To: T10 Technical Committee
From: Robert Sheffield (Robert.L.Sheffield@intel.com), Intel Corporation
Date: January 7, 2004
Subject: T10/04-030r0, SAS-1.1: Fix SP Hang States

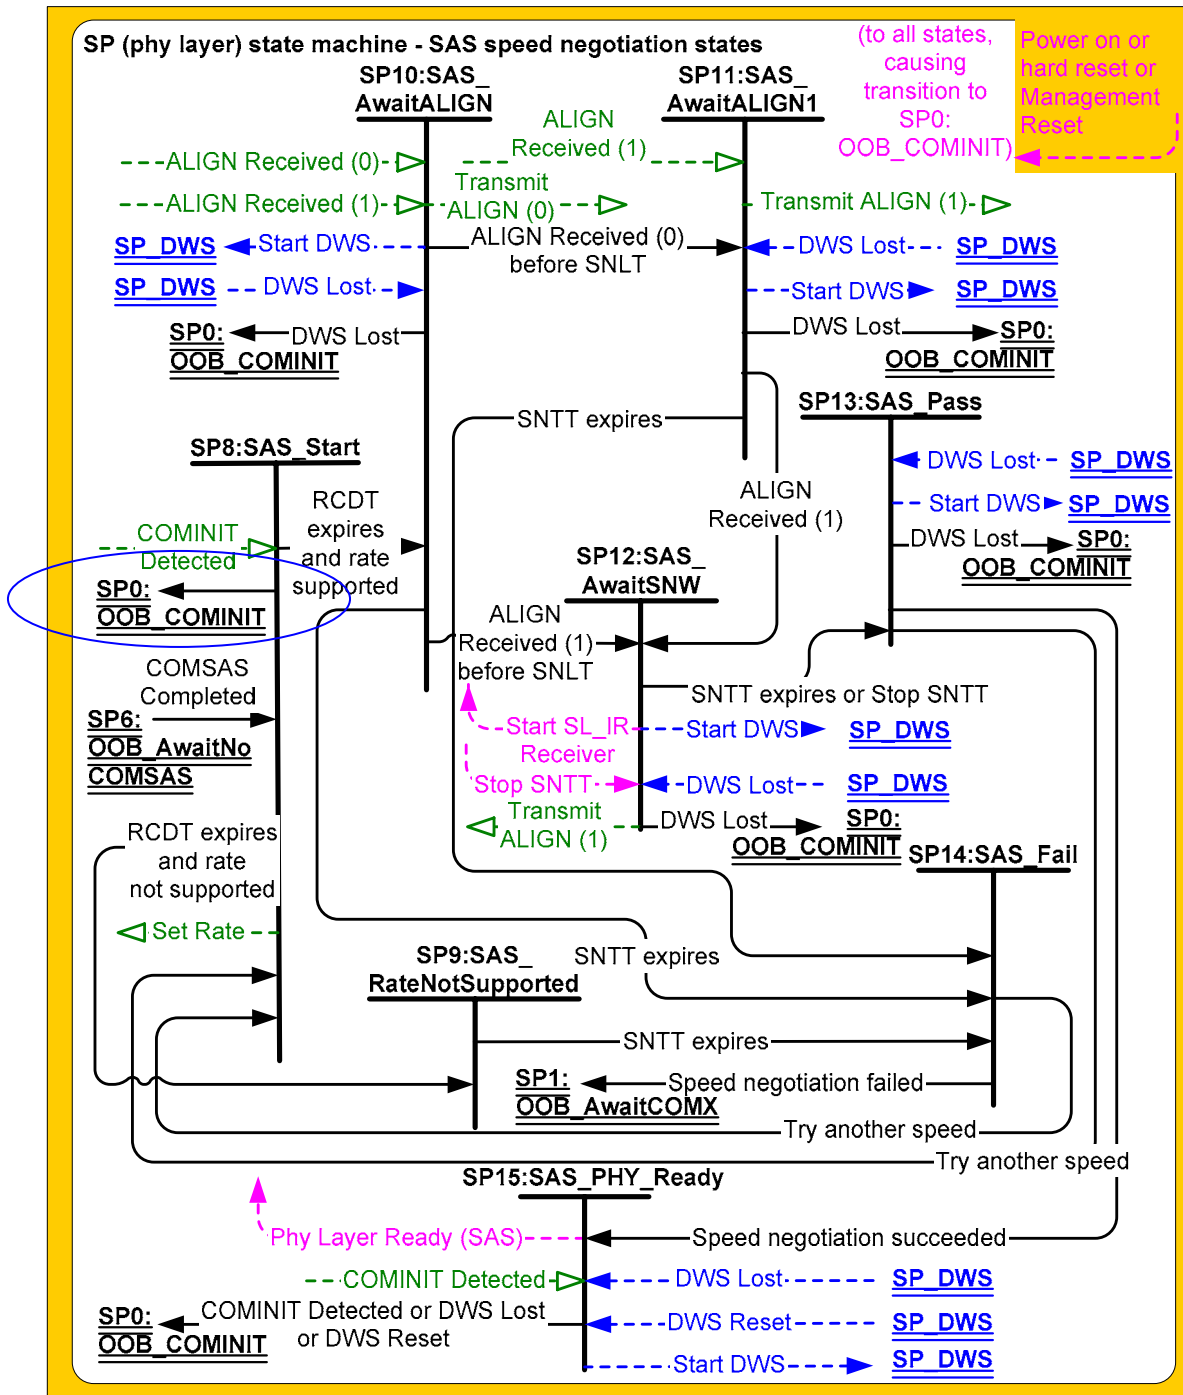
Modify subclause 6.7.3.9.1 as shown to capture COMINIT Detected as a trigger for that transition:

6.7.3.9.2 Transition SP7:OOB_AwaitCOMSAS to SP0:OOB_COMINIT

This state shall send a SATA Spinup Hold confirmation to the link layer and perform this transition if.

- a) this phy is in an expander device;
- b) this phy supports attachment to a SATA device;
- c) the COMSAS Detect Timeout timer expires;
- d) this expander device implements SATA spinup hold; and
- e) the SP0:OOB_COMINIT state was not originally entered because of an SMP Reset request (i.e., SMP PHY CONTROL-based requests to reset the phy bypass spinup hold).

| This state shall perform this transition after receiving a COMINIT Detected message.
